**NOTICE OF ADDENDUM
ADDENDUM NO. 2**

**CONTRACT NO. 7939
MADISON MUNICIPAL BUILDING - RENOVATION**

This addendum is issued to modify, explain or correct the original Drawings, Specifications, or Contract Documents and is hereby made a part of the contract documents.

4 ELECTRICAL VAULT ROOF FRAMING PLAN
 1/4" = 1'-0"

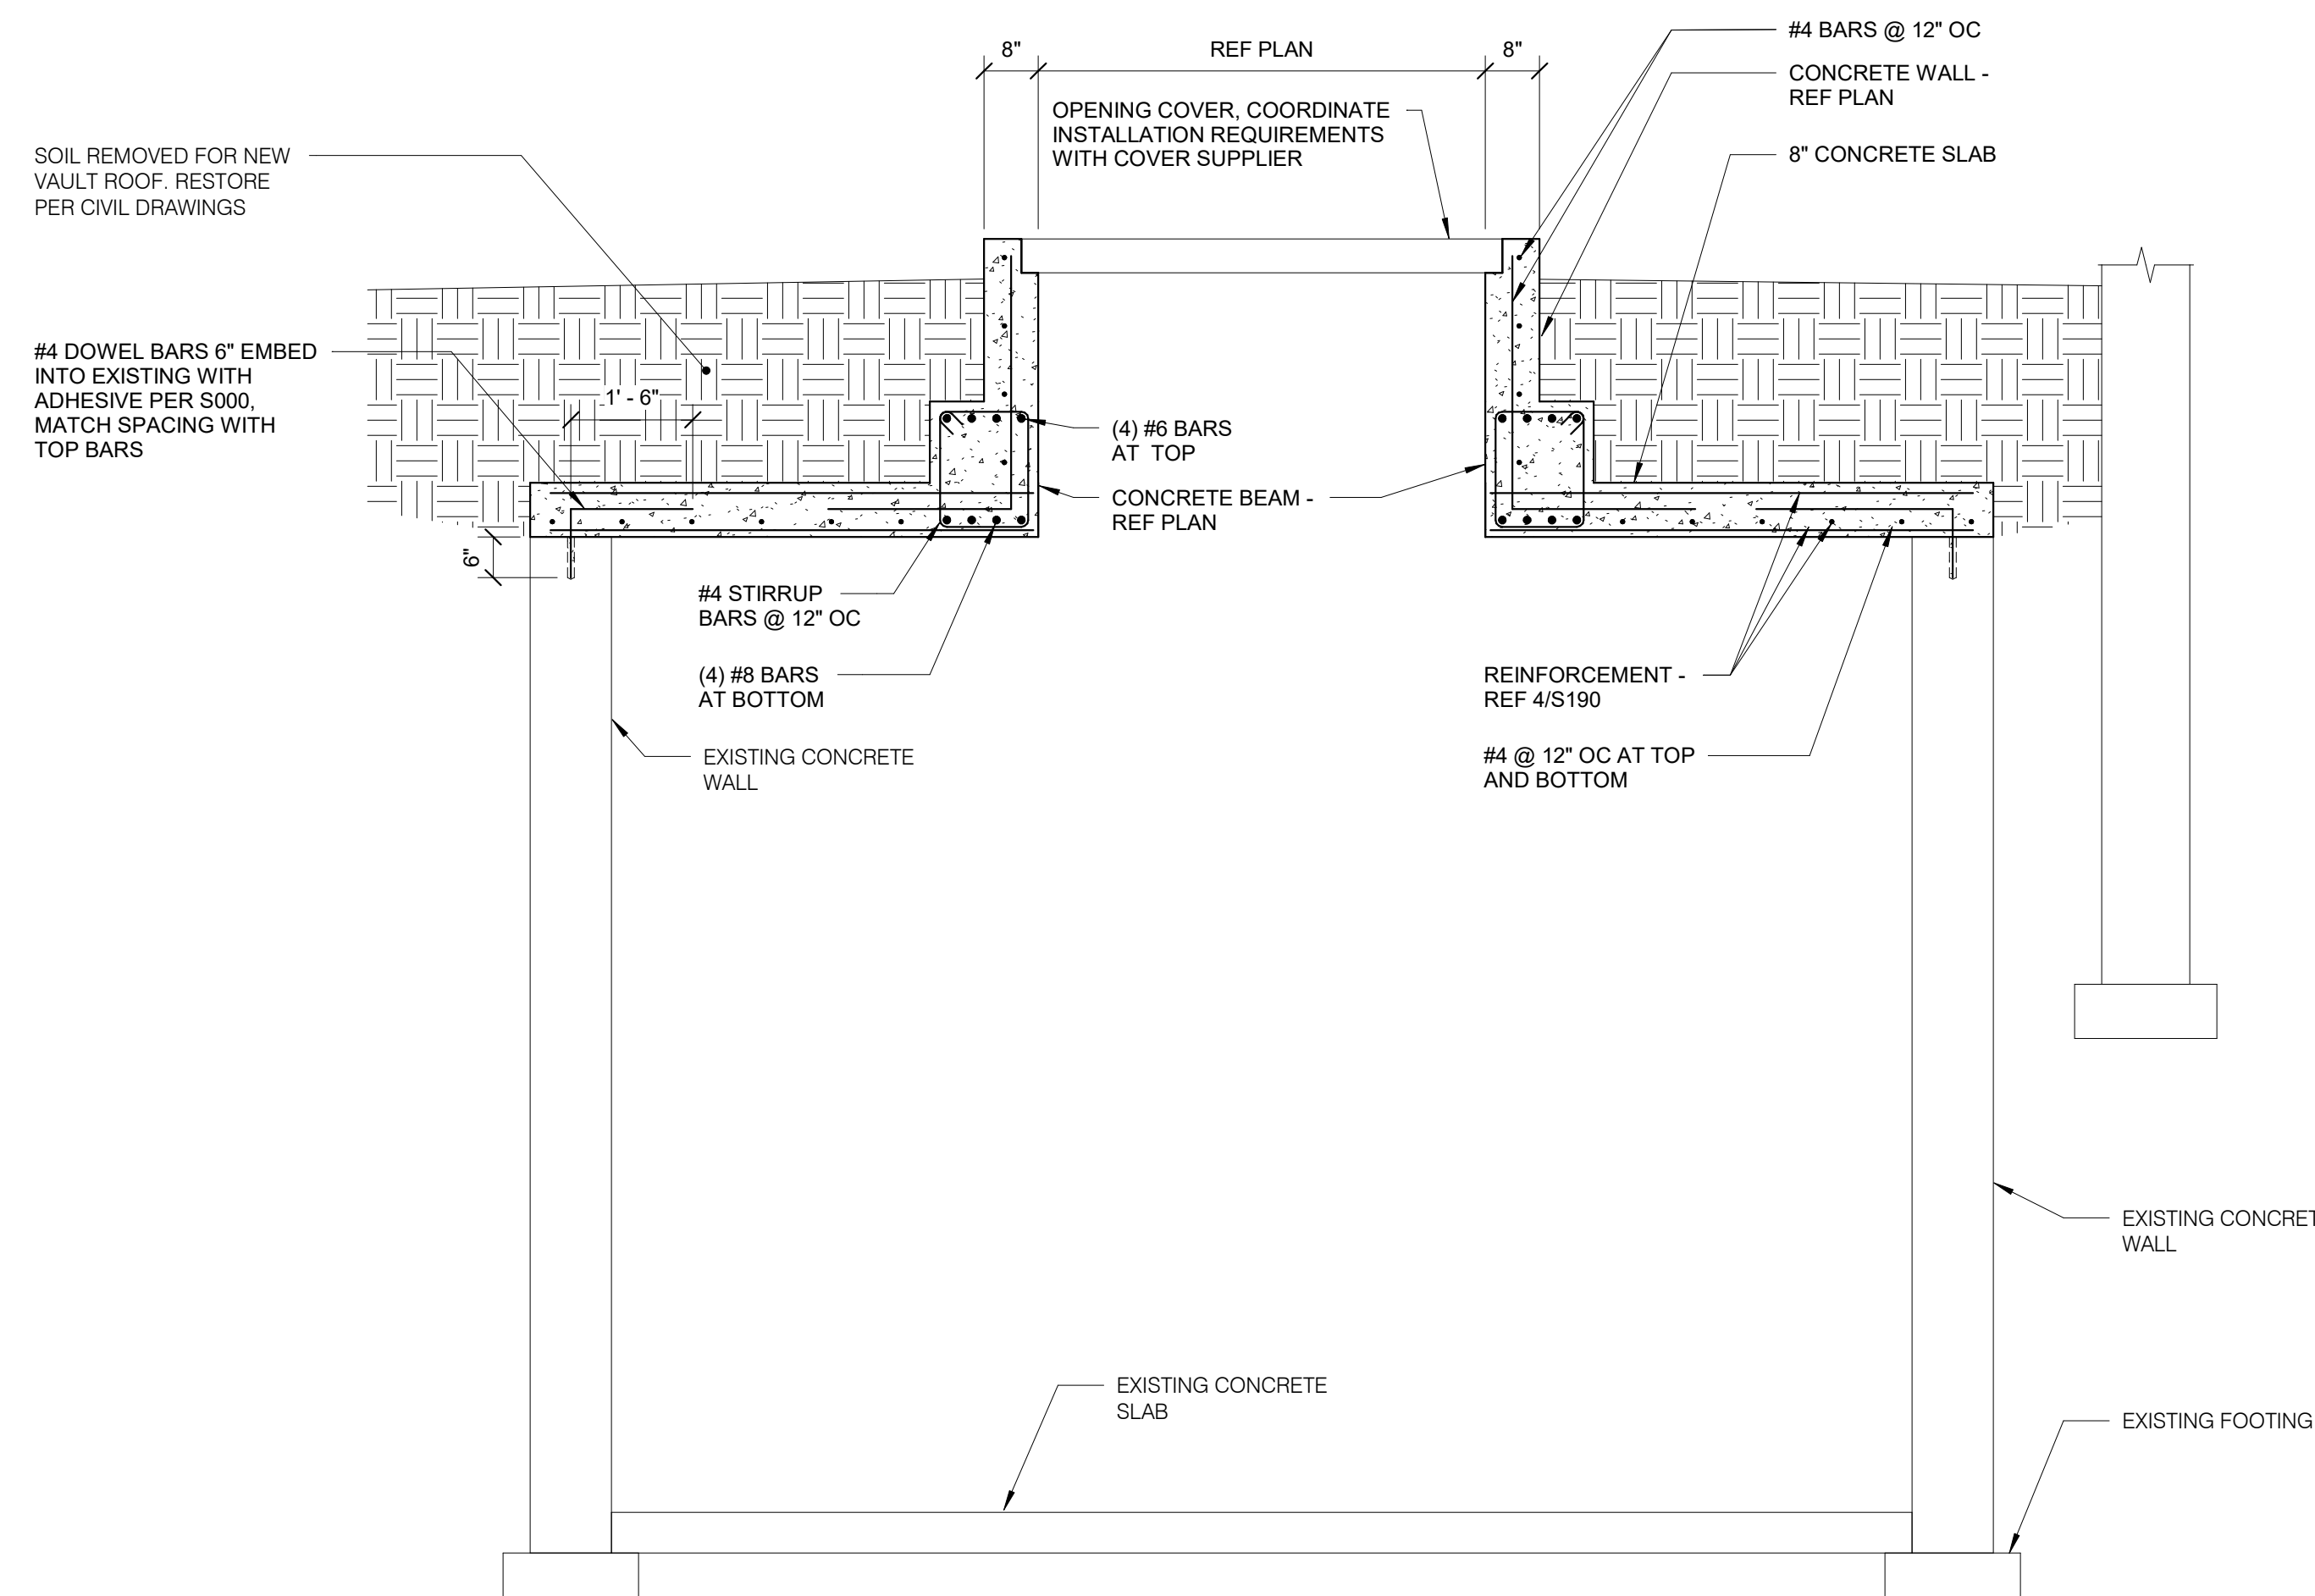
- a. **REVISE** enlarged ceiling framing plans per revised sheet S190.
6. Drawing S201 – FOUNDATION DETAILS
 - a. **ADD** dowel spacing in detail 6 to be 16” oc per revised sheet S201.
